**TRANSPORT STATEMENT**  
**Land at South Side, Steeple Aston**

Prepared for: Rectory Homes  
Ref: TR8171225/TF/DW/021  
Issue 2: 4 December 2019

### **Oxfordshire County Council's Consultation Response to Application No. 18/01482/F and 19/01177/F**

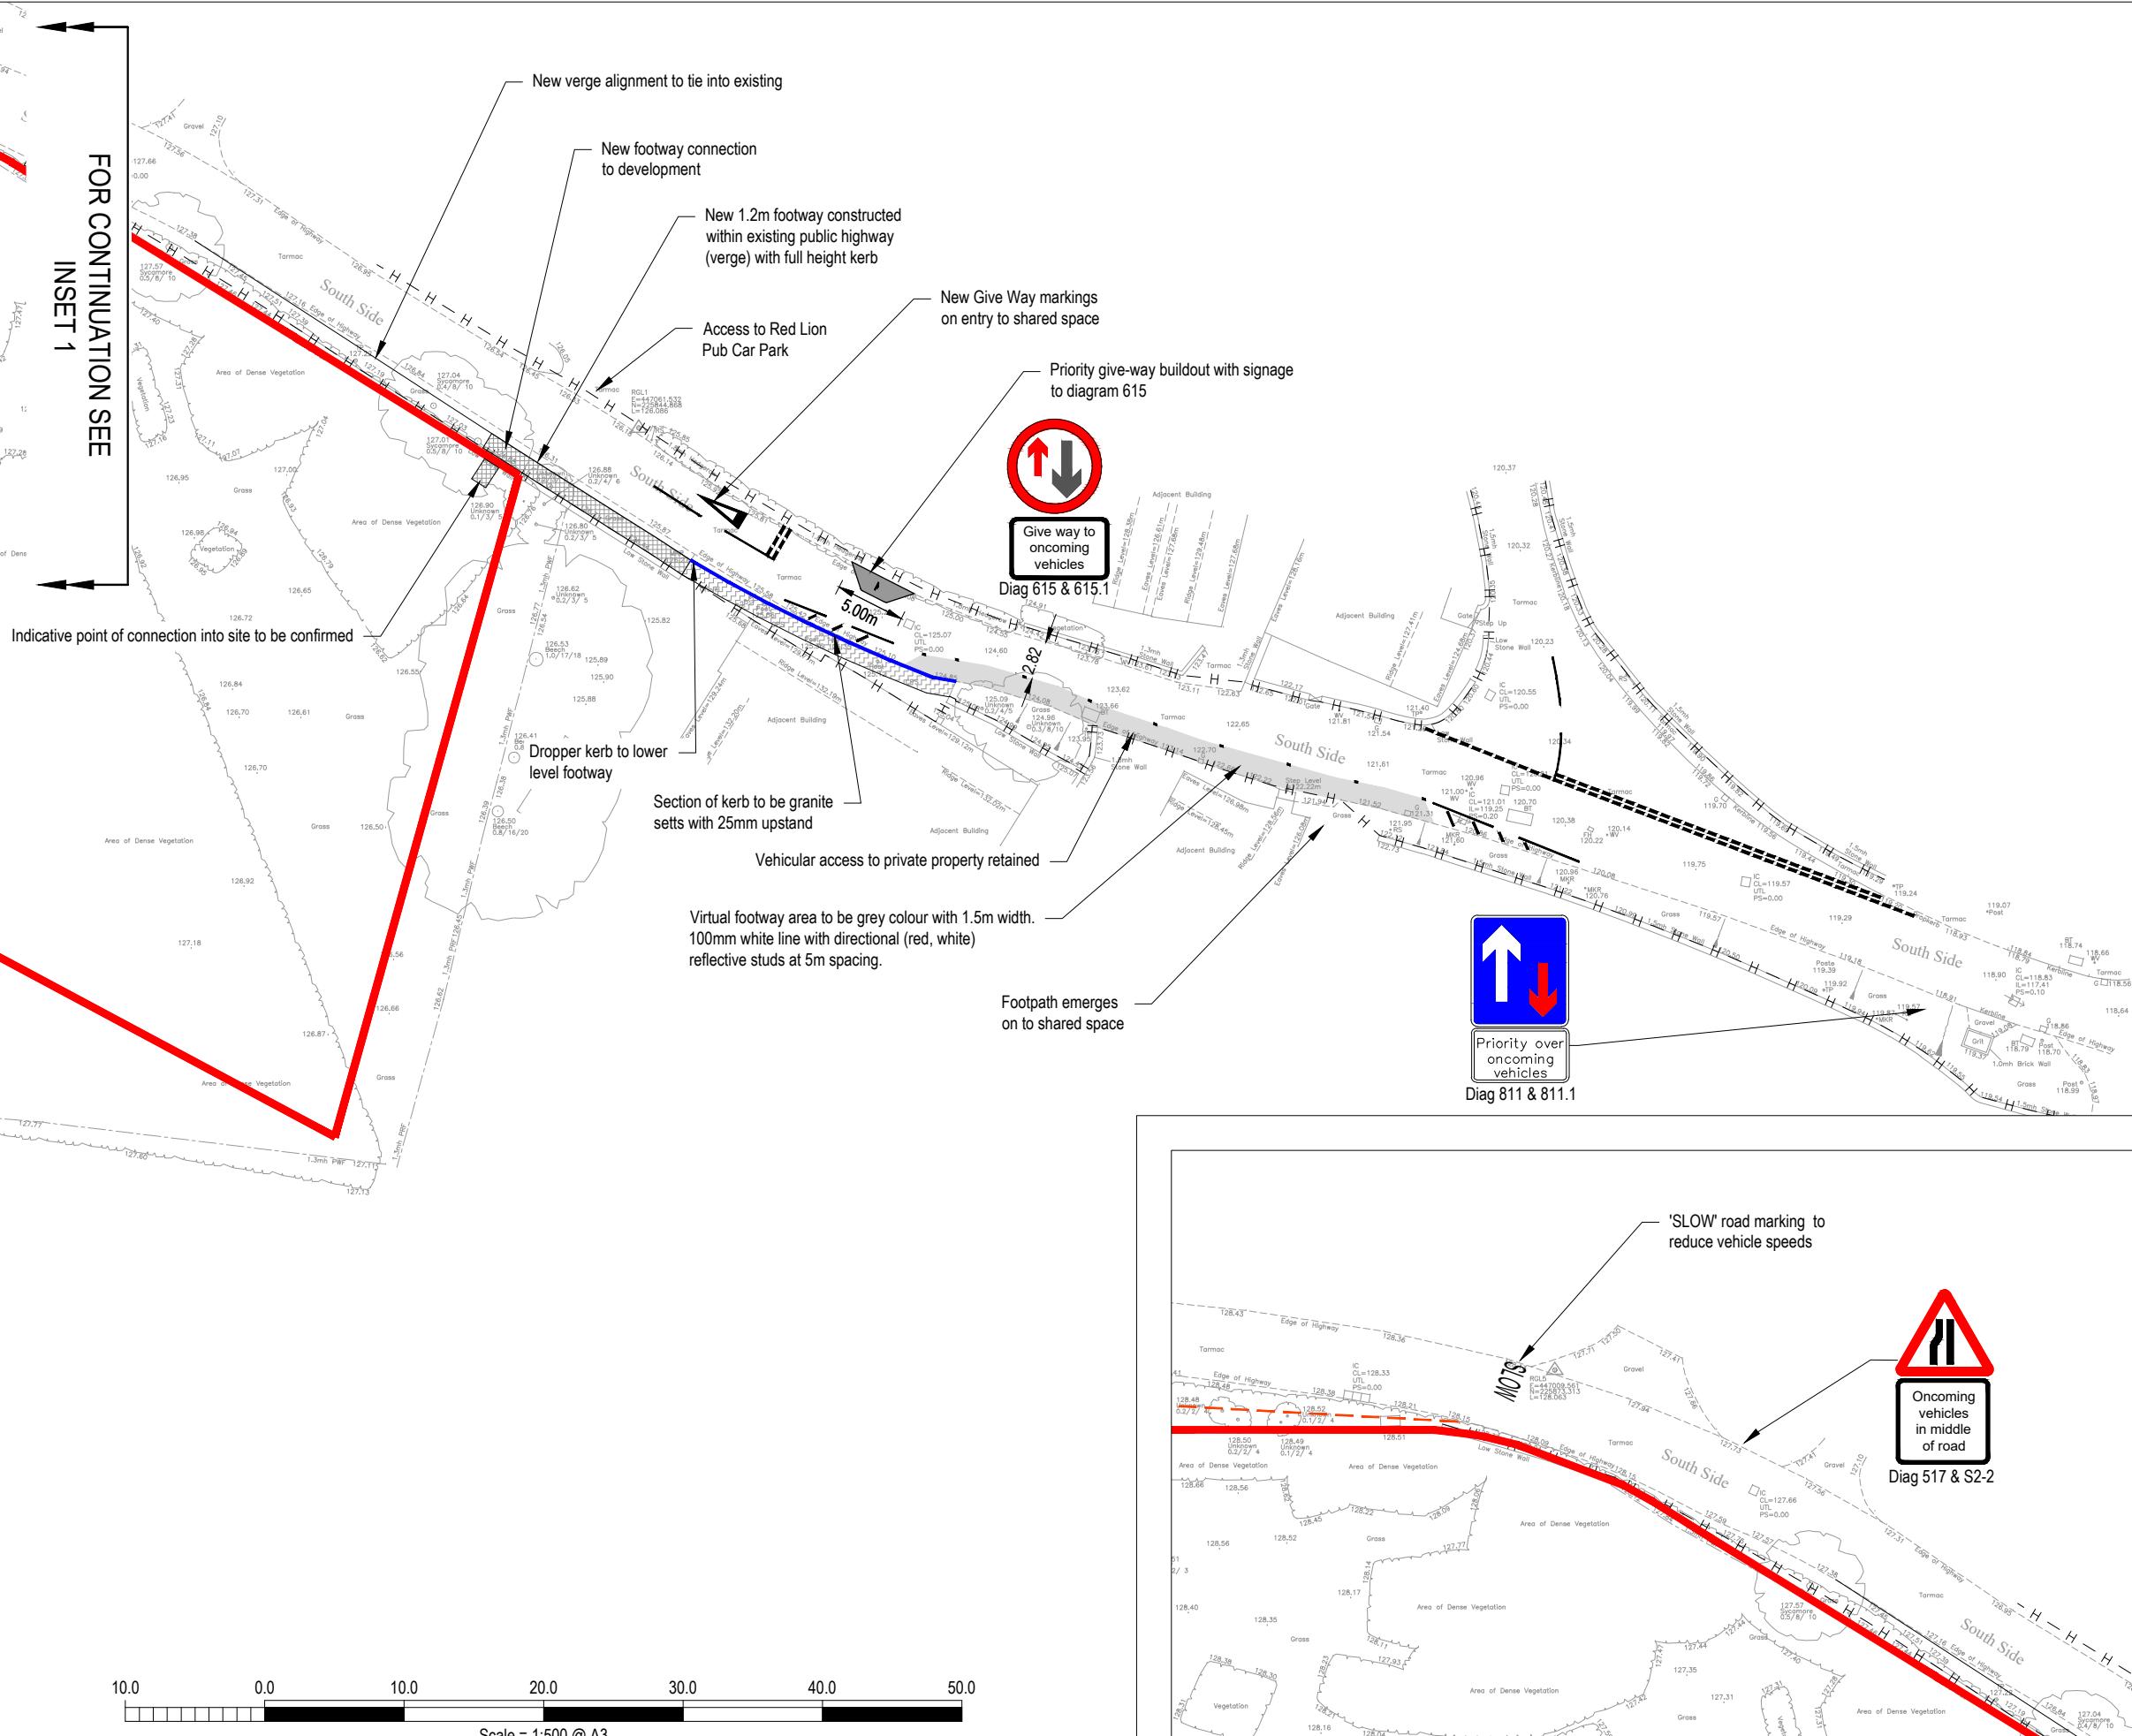
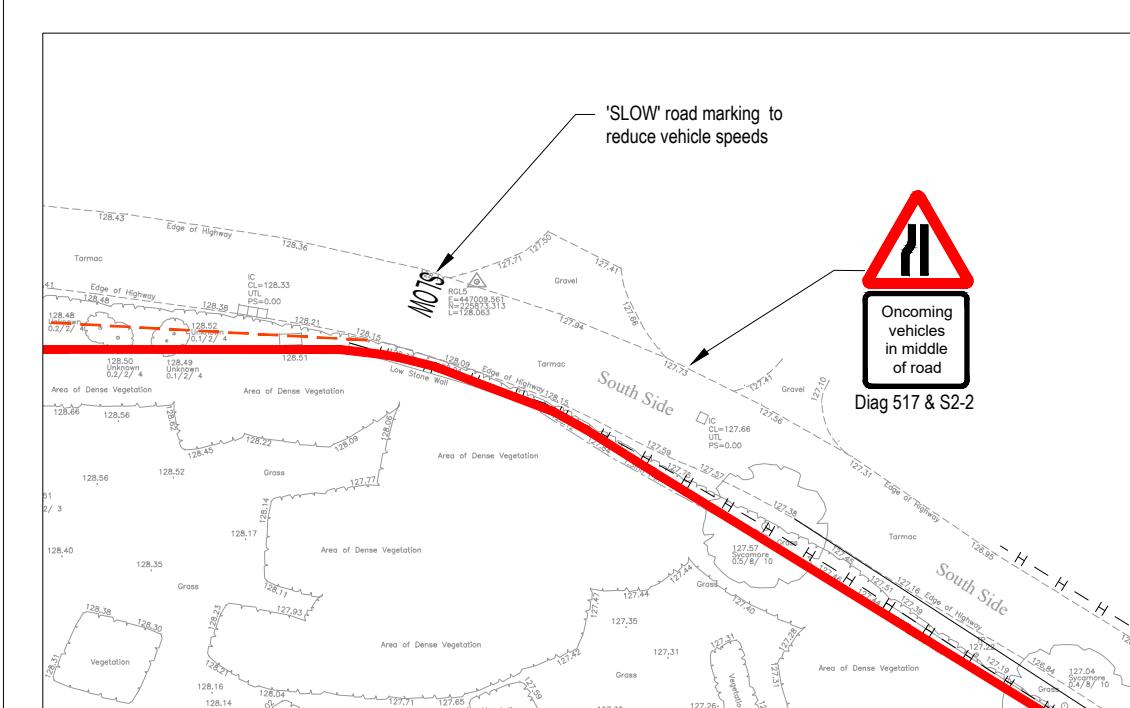
OCC have some outstanding comments on this drawing which have been communicated (ref. email in Appendix G of the TS) but which are yet to be incorporated:

- We are still of the opinion that the priority sign to diagram 615 needs to be lit. The TSRGD requires this to be illuminated as it is within 50m of a street light which forms part of a system of street lighting, and it is a 30mph speed limit.
- The 811 sign is not in a suitable position as it is too distant from the build-out. As it is an advisory sign there is no requirement to provide it in conjunction with 615, but we would prefer that the sign is provided, assuming that a suitable alternative location can be found, taking account of site constraints. The 811 sign does not need to be lit.
- The virtual footway should be buff colour, rather than grey.

I can confirm that OCC agree in principle to the pedestrian improvements illustrated in drawing 8171225/6110 Rev. A1 (dated 10/4/2019). Should the applicant propose these improvements as part of a full application then OCC would not object on that basis.

We do have some further comments on this revised drawing, but these will not impact our in-principle agreement:

- We are still of the opinion that the priority sign to diagram 615 needs to be lit. The TSRGD requires this to be illuminated as it is within 50m of a street light which forms part of a system of street lighting, and it is a 30mph speed limit.
- The 811 sign is not in a suitable position as it is too distant from the build-out. As it is an advisory sign there is no requirement to provide it in conjunction with 615, but we would prefer that the sign is provided, assuming that a suitable alternative location can be found, taking account of site constraints. The 811 sign does not need to be lit.
- The virtual footway should be buff colour, rather than grey.

2.8 Problem 8

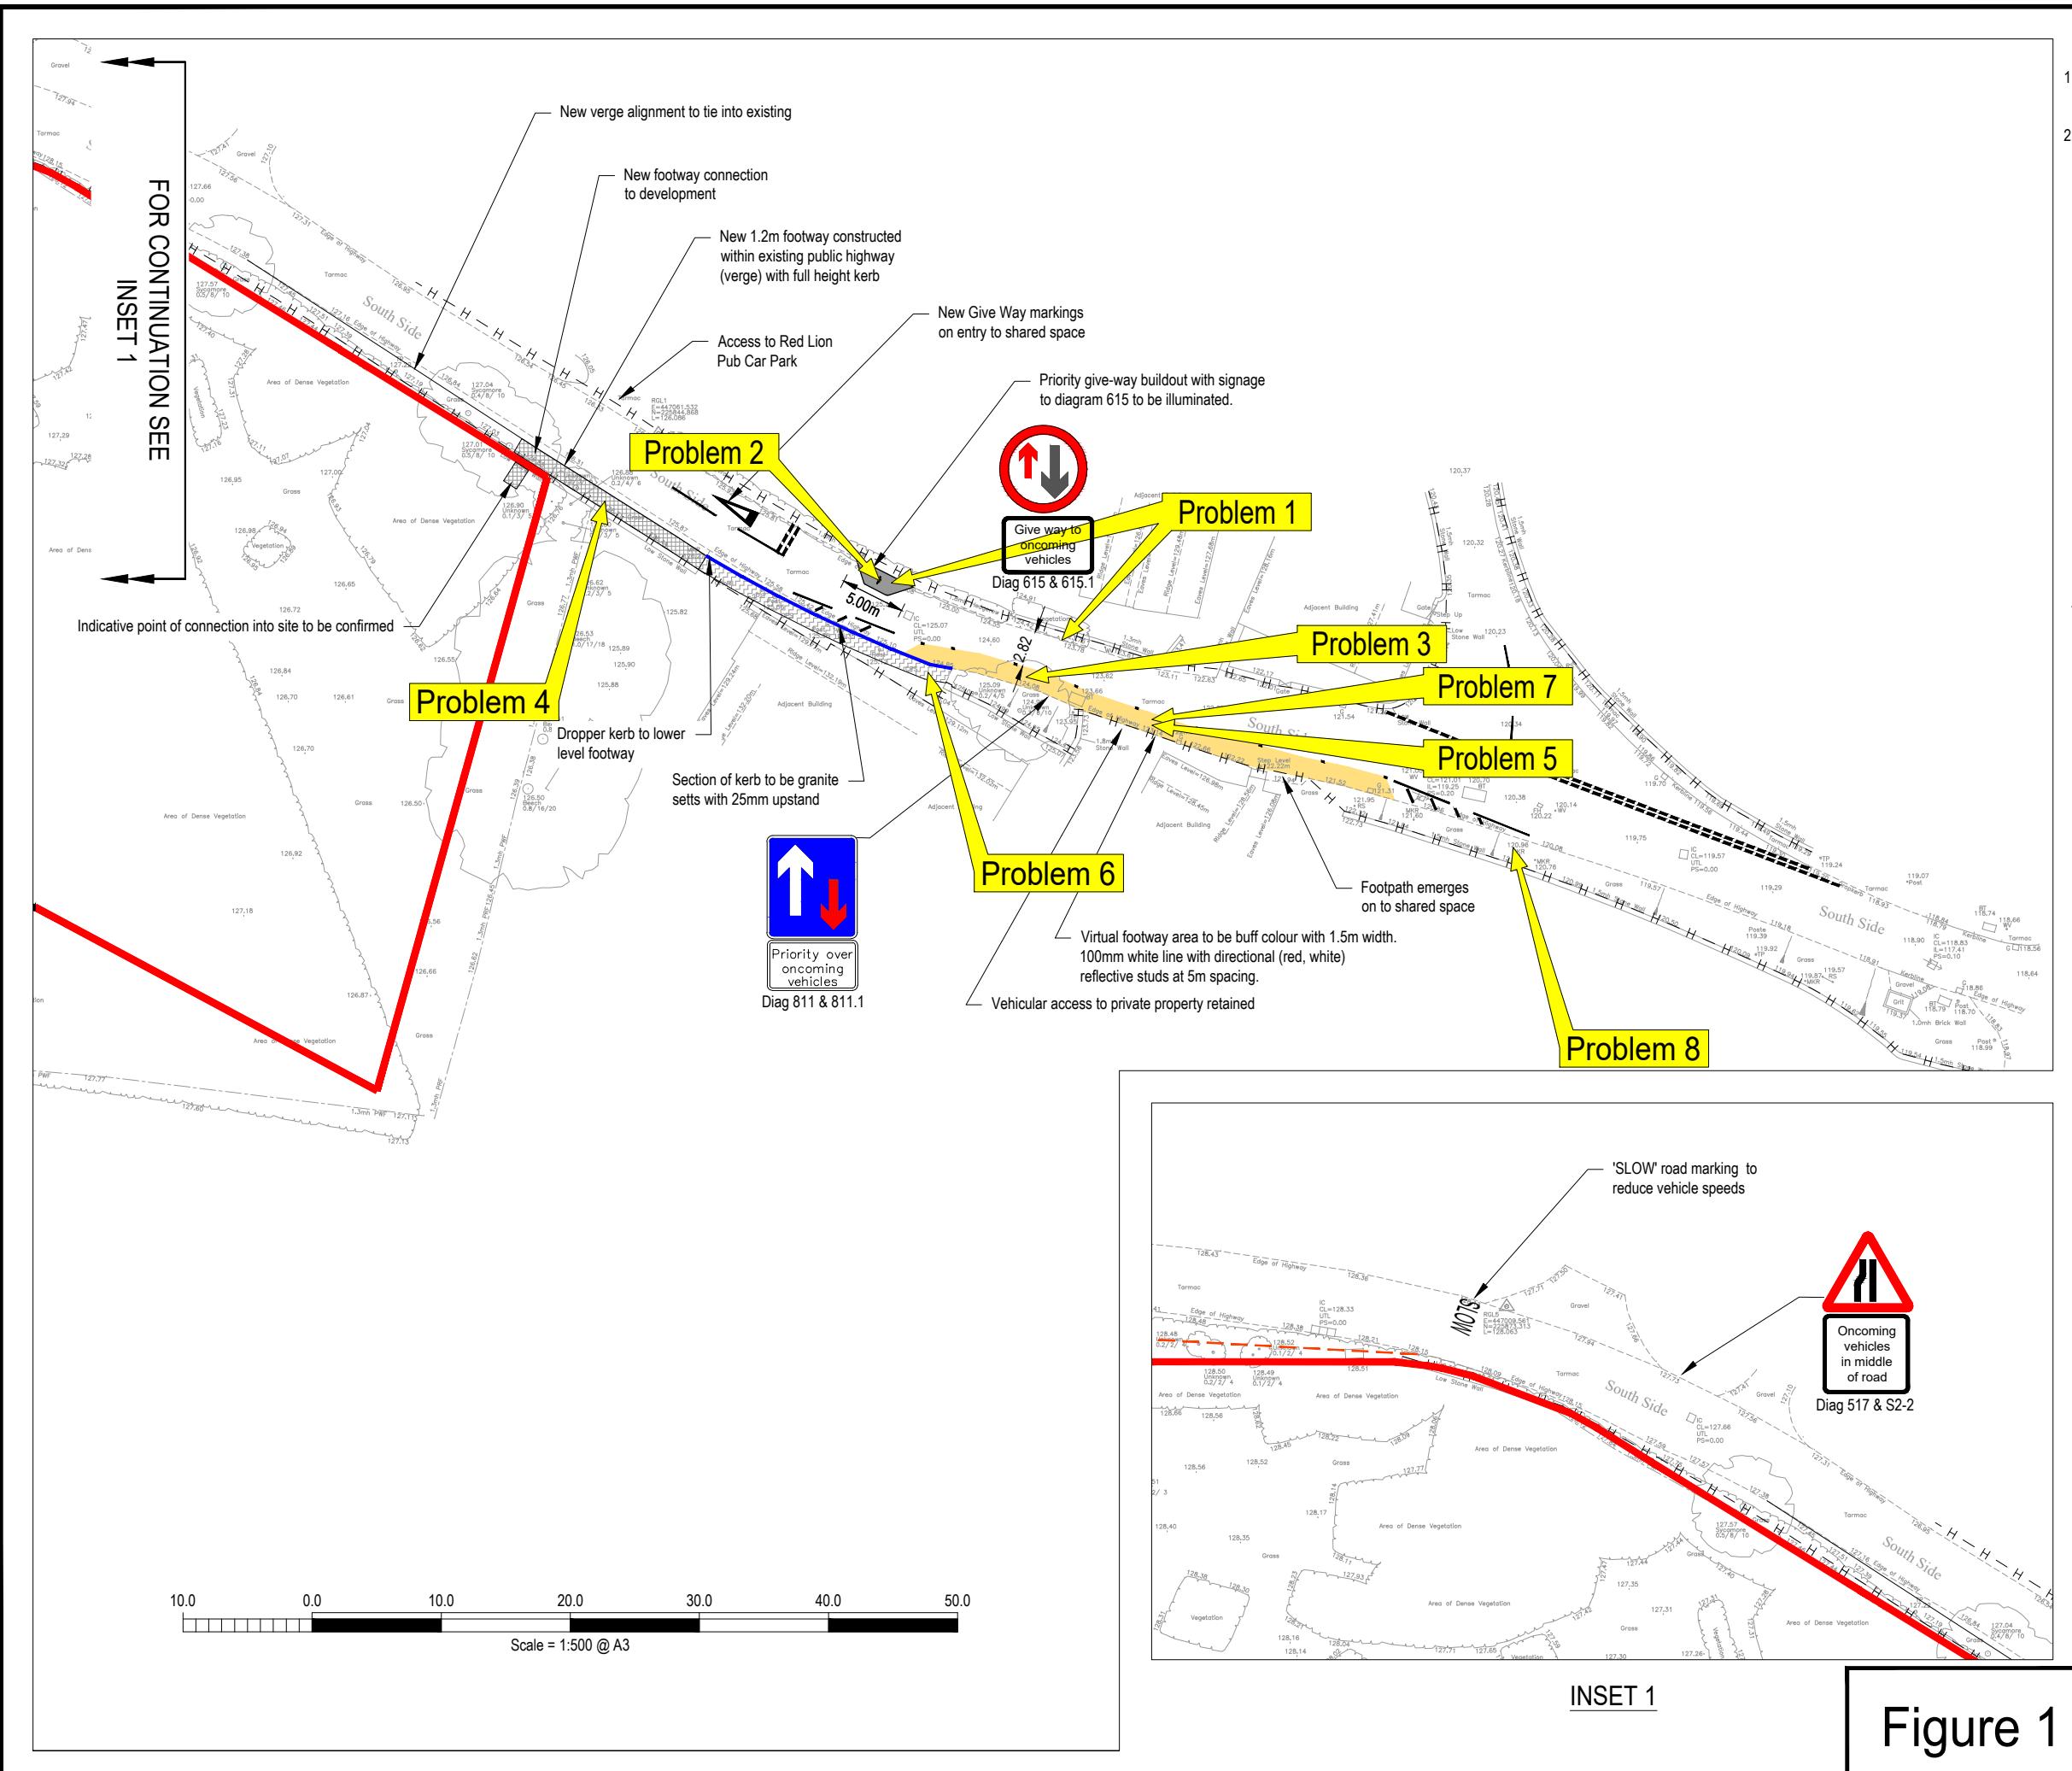
Location: Eastern end of virtual footway.

Summary: Risk of pedestrian / vehicle collisions leading to personal injury.

Two bollards have been added to the design to demarcate the eastern end of the over-runnable footway.
